Product Change Notification

Date Issued :	May 19, 2022	PCN Number :	512042
Reason for Change :	Capacity change or tool replacement		
Description of Change :	This notice is to inform you that Molex Lincoln Nebraska is adding new capacity tooling. Tooling will be an exact replica of current tooling and there will be no change to product when compared to current tooling.		
Reason for Short Notice :	Capacity Increase		
Assessment of Change :	First Article Inspection		
Planned Implementation Date :	July 08, 2022		
Sample Availability Date:	June 10, 2022		
Internal Molex Qualification Date :	June 24, 2022		
Last date to request Samples by Customer :	June 30, 2022		
Traceability Code Markings / Date :	Product made after planned implementation date can contain the change

■ 5557 Series

— Mini-Fit Jr. Receptacle Housing

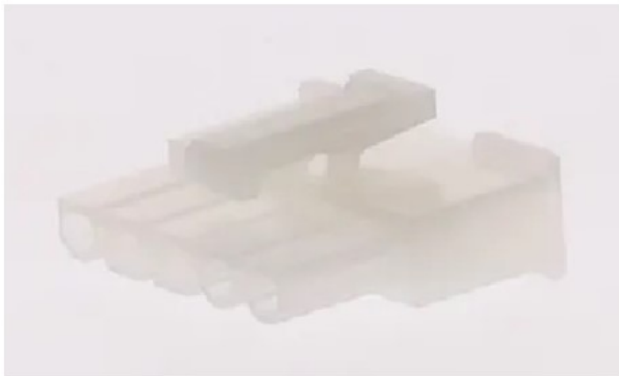
- To ensure business continuity, another set of tooling is being added
 - New tooling will be an exact replica of current tooling
 - Tooling being added to keep up with current and future demand
 - Tooling only being added to Molex Lincoln Nebraska location
- There is NO impact to Fit, Form or Function
- Samples and Qualification reports available upon request after dates shown above
- Part Numbers Impacted
 - See attached list
